Precinct Structure Plan Response

Croskell Precinct Structure Plan

Date	9 October 2024
Project No.	24030 00 v1.0
Author	Jamie Tainton
Client	Wolfdene c/o Marshal

Figure 37: Future overland flow path PSP Road Section (including pipe and proximity to the VDP cable) - Cross-section fill example

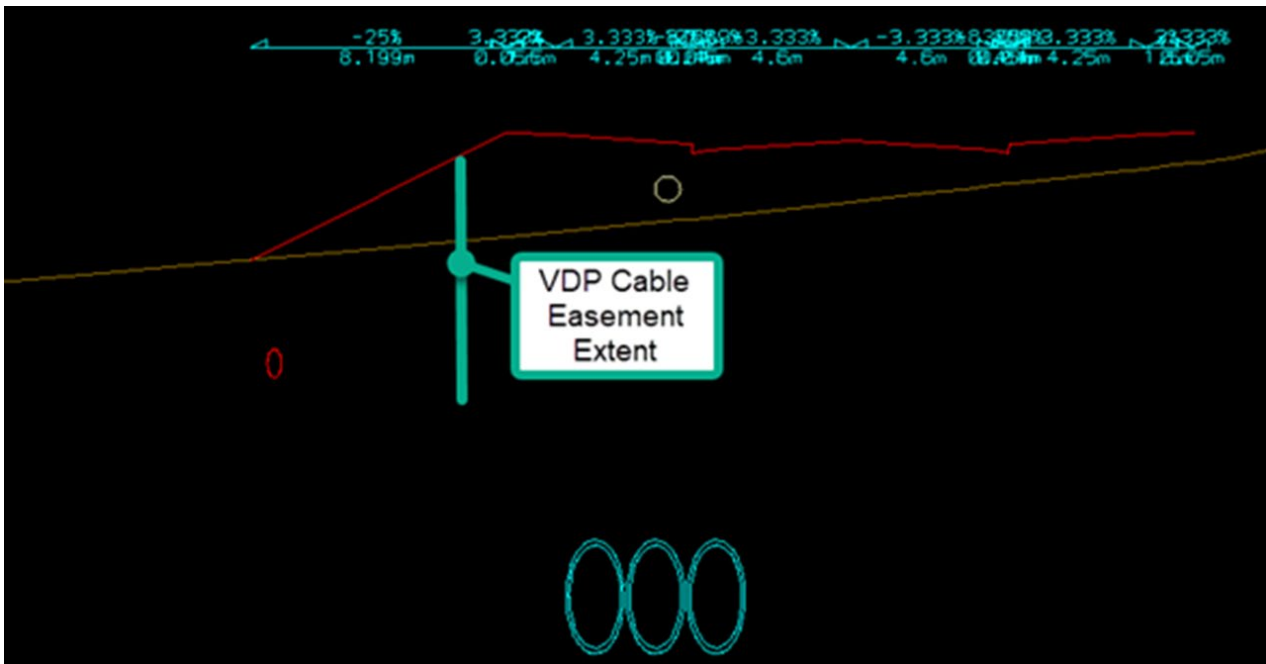
Retaining walls are likely to still be required along the interface of the VDP cable easement, however in their highest extent will only be some ~2.0m in fill. We note that localised grading in more detail may completely remove any need for a filled solution as shown in Figure 30 below.

Figure 38: Extent of cut (red) and fill (blue)

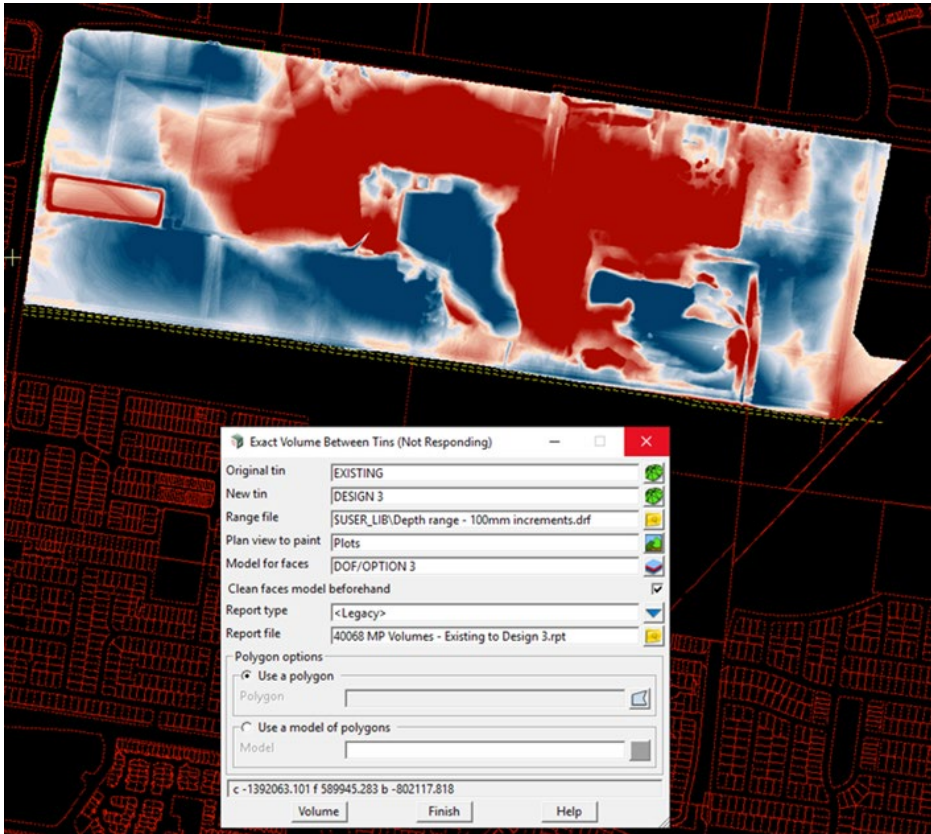
When looking at the earthworks (refer to Figure 31) for this scenario we can see that the need for cut will be dramatically reduced when compared to the Exhibited Solution. Instead of >2.2mil m³ we are expecting around 1.4mil m³ of cut and together with the fill, looks like 1.9mil m³ instead of 2.5mil m³ of earthwork moved around the site (details can be found in Table 11). This still excludes the requirements for the large pads expected in an employment area like this.

Figure 39: 1% pipe outlet arrangement (no swale)

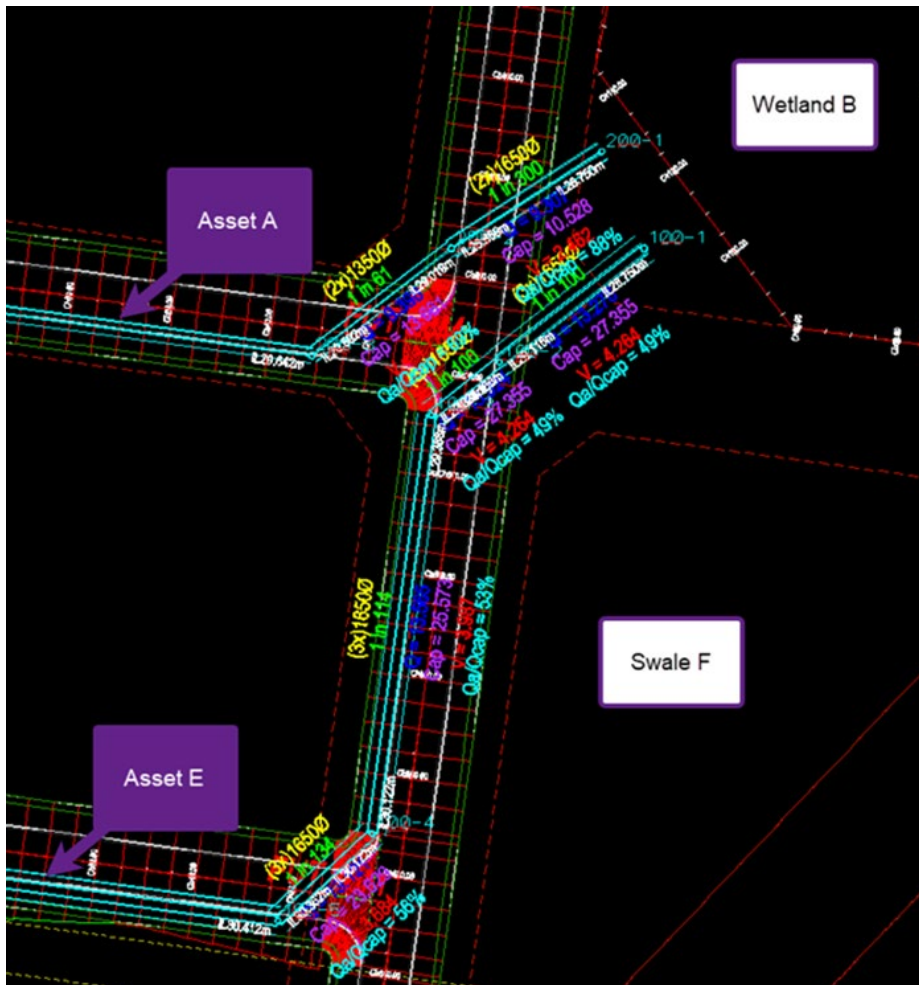
Another benefit of putting the flows into a pipe is the removal of Swale F as shown in Figure 39. Here we have shown the probable location of the 1% pipe within the road reserve. Depending on the future location of the road, this could unlock more land for development.

Figure 40: Proposed Drainage Scheme (Ideal Scenario)

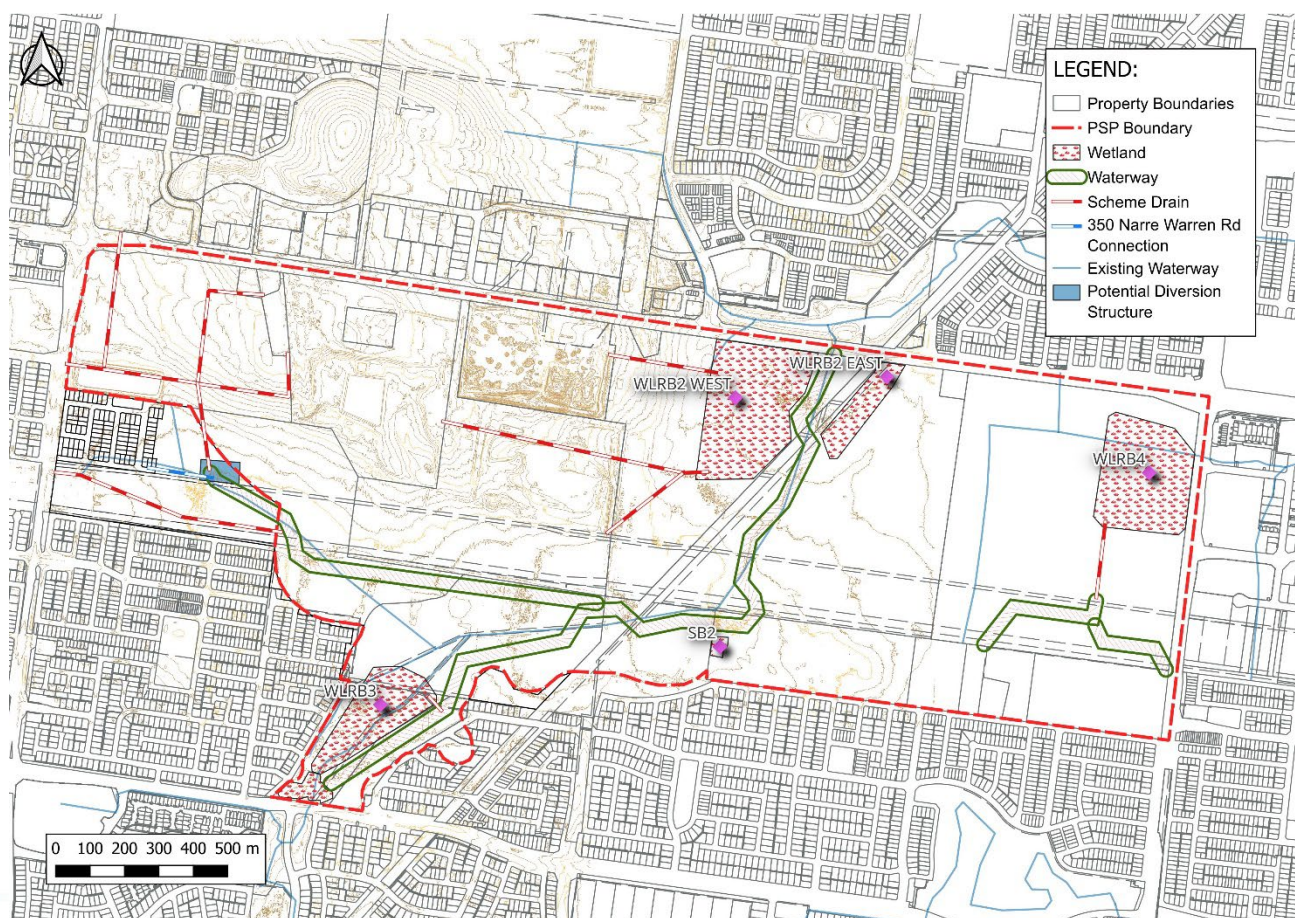
The ideal drainage scheme layout, as adapted from the VPA exhibited solution can be seen below in Figure 40 and looks to work with the topography instead of fighting it. By allowing the entire western catchment to go over the VDP cable in the west we avoid the unnecessary need for 1% pipes or deep overland flow paths that bring in risk.
